Access Compliance Report to accompany a

Development Application

Development Address: 9-13 Goulburn Street, Warwick Farm

Client: VENTUS Group c/o Urban Link Architects

Basement 02 shown above

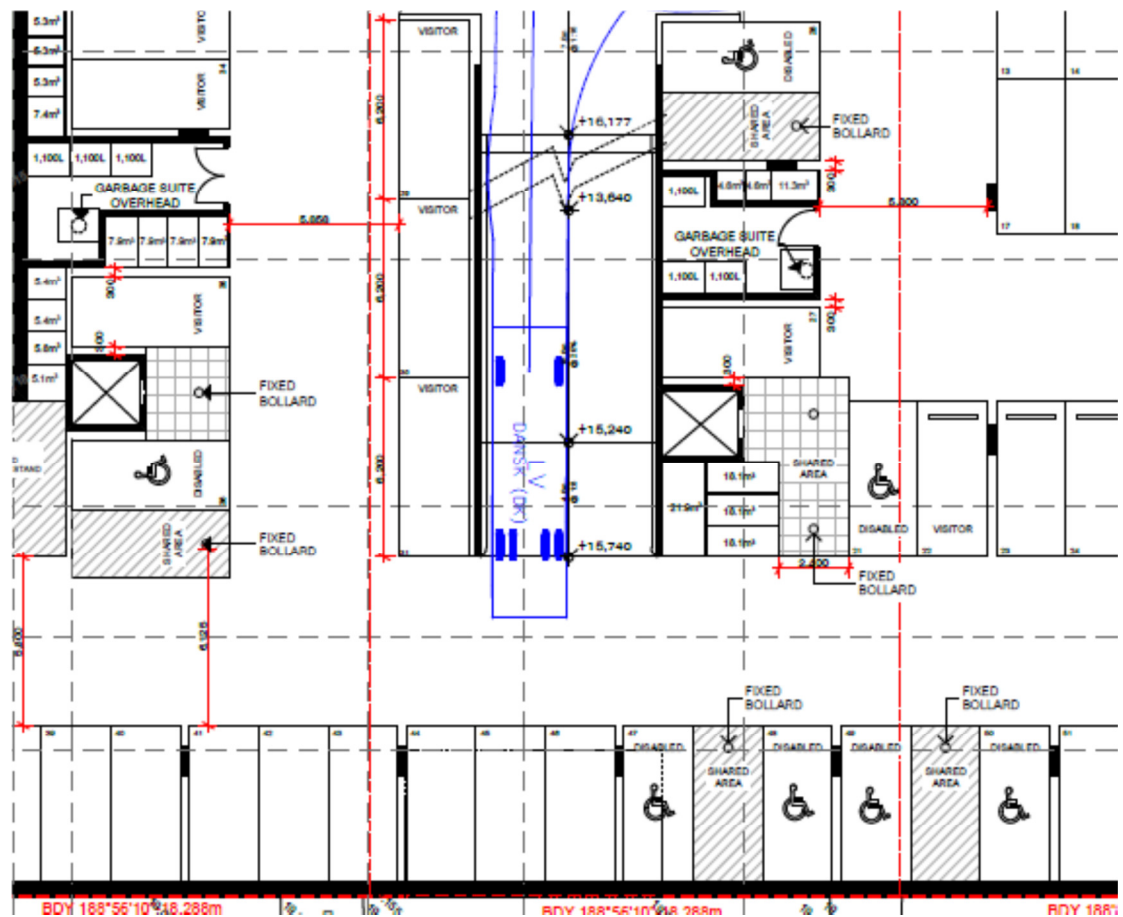
BCA Part D3.5 Accessible Carparking
Requirement	Class 2 There are no carparking requirements for a Class 2 under the BCA. If adaptable housing has been mandated by the Council, carparking spaces will be required under the requirements of AS4299- Adaptable housing.
Compliance Comments	Complies. Liverpool Council requires provision of 10% Adaptable units in the development. Development has total number of 101 units. 10% of 101 = 11 required Adaptable units. Therefore 11 accessible carparking spaces are required. 11 Accessible car parking spaces have been provided in development. One accessible parking space is required to be allocated to each of the Adaptable units. Detailed features of the accessible/ adaptable parking spaces are to be verified at CC stage of works.

Basement 01 shown above

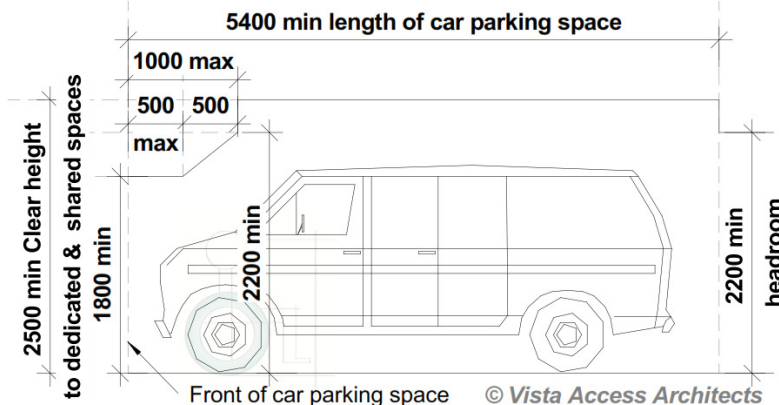
Note: All shared zones to be not less than 2.4M in width.

PRE-ADAPTABLE - UNITS B.G002, B.1002, B.2002, B.3002, B.4002, B.5002
1:50

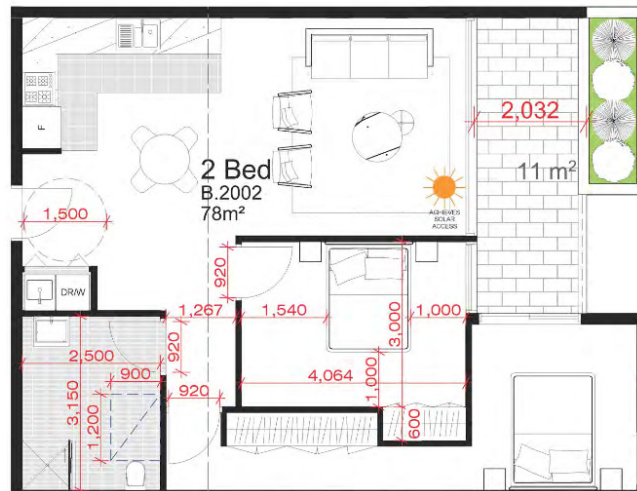
At DA stage there is insufficient information to certify compliance with the Standard, however, in accordance with the table below, the nominated units can comply with the spatial requirements of AS4299 for Adaptable Housing.

PRE-ADAPTABLE - UNITS B.G004, B.2004, B.3004, B.4004, B.5004
1:50

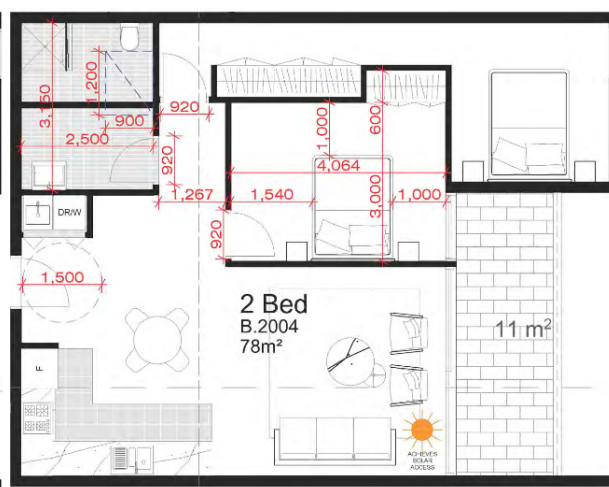
By incorporating the essential requirements listed below in the Specifications, the nominated Adaptable units can achieve full compliance with Adaptable House Class C

Main bedroom

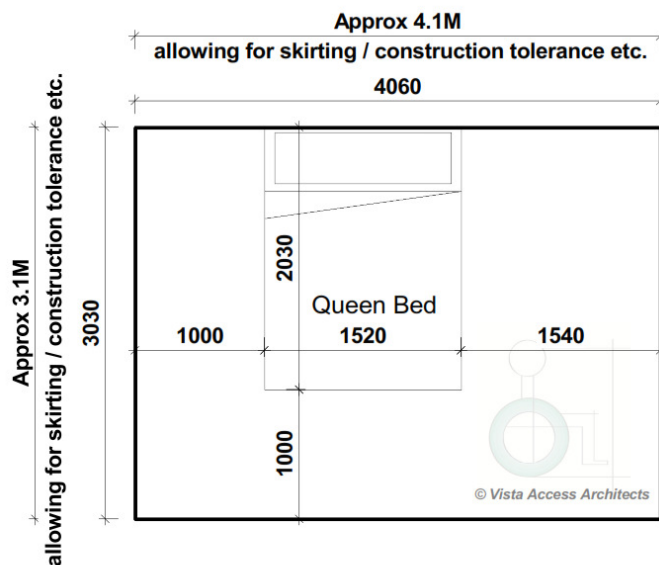
Mirror layout will also comply.

62	4.6.1	At least one bedroom of area sufficient to accommodate queen size bed and wardrobe and circulation space requirements of AS1428.2	✓	✓	A space of 1.54Mx2.07M at the base or one side of the bed is considered to be compliant.
		Main Adaptable bathroom			
75	4.4.1	Provision for bathroom area to comply with AS1428.1	✓	✓	A bathroom with minimum space of 2Mx 2.95M or 2.3Mx2.7M or 2.4Mx2.45M is required.

Post Adaptation bathroom layout shown above

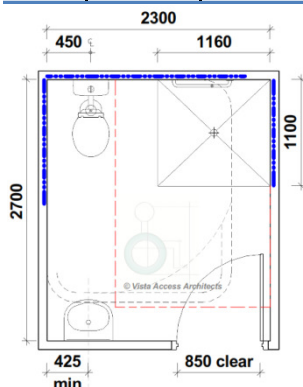
Noted dimensions on the above diagrams are approximate and depend on selected features such as size of the basin. Thick blue line indicates the location of wall reinforcements. Red dotted line indicates the shower circulation space. Black dotted line indicates the WC pan circulation space.

Reinforcement requirements for the Adaptable unit- Shower (in post adaptive position) showed hatched.
Refer to AS4299 for further details.
Note: Shower seats are not required to be provided in Adaptable units.

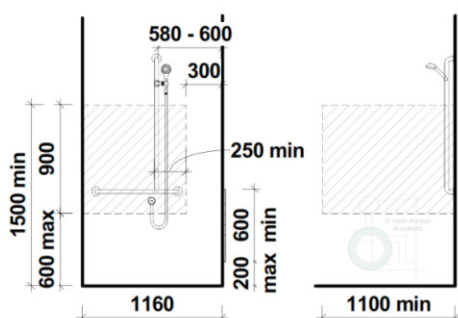
77	4.4.4 f	Shower recess - no hob. Minimum size 1160x1100mm to comply with AS1428.1	✓	✓	Add to Specifications.
78	4.4.4 f	Shower area waterproofed to AS3740 with floor to fall to waste	✓	✓	Add to Specifications.
79	4.4.4 f	Recessed soap holder	✓	✓	If recessed is not provided a heavy duty load bearing soap holder will be required.
80	4.4.4 f	Shower taps positioned for easy reach to access side of shower sliding track.	✓	✓	Add to Specifications.
82	4.4.4 h	Provision for adjustable, detachable hand held shower rose mounted on a slider grabrail or fixed hook plumbing and wall-strengthening provision (unless brick walls provided)	✓	✓	Reinforcement to wall to take the grabrails has to be provided as per requirements of AS4299
83	4.4.4 h	Provision for grabrail in shower to comply with AS1428.1	✓	✓	Add to Specifications.

Reinforcement requirements for the Adaptable unit- WC pan (in post adaptive position) showed hatched.
Refer to AS4299 for further details.

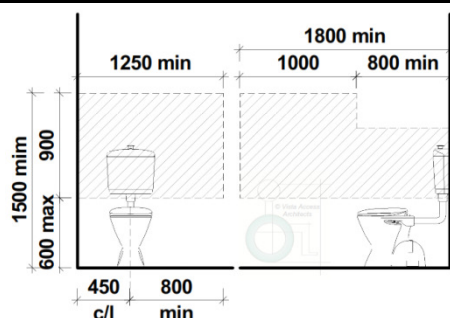
83	4.4.4 h	Provision for grabrail in shower to comply with AS1428.1	✓	✓	Add to Specifications.
86	4.4.4 c	Tap sets to be capstan or lever handles with single outlet	✓	✓	Add to Specifications.
88	4.4.4 g	Provision for washbasin with clearances to comply with AS1428.1	✓	✓	Min of 425mm is required from the side wall to the centre line of the basin. Basin is required to be at least 300mm away from door swing.
90	4.4.4 d	Double GPO bedside mirror	✓	✓	Add to Specifications.
		Toilet			
92	4.4.3	Provision of either 'visitable toilet' or accessible toilet	✓	✓	Visitable is provided. Accessible can be provided post-adaptation.
93	4.4.1	Provision to comply with AS 1428.1	✓	✓	
94	4.4.3	Location of WC pan at correct distance from fixed walls	✓	✓	450mm – 460mm is required from the side wall to the centre line of the WC pan. Add to Specifications.
95	4.4.4 h	Provision for grabrail zone.	✓	✓	Reinforcement to wall to take the grabrails has to be provided as per requirements of AS4299 unless brick walls have been provided. Add to Specifications.
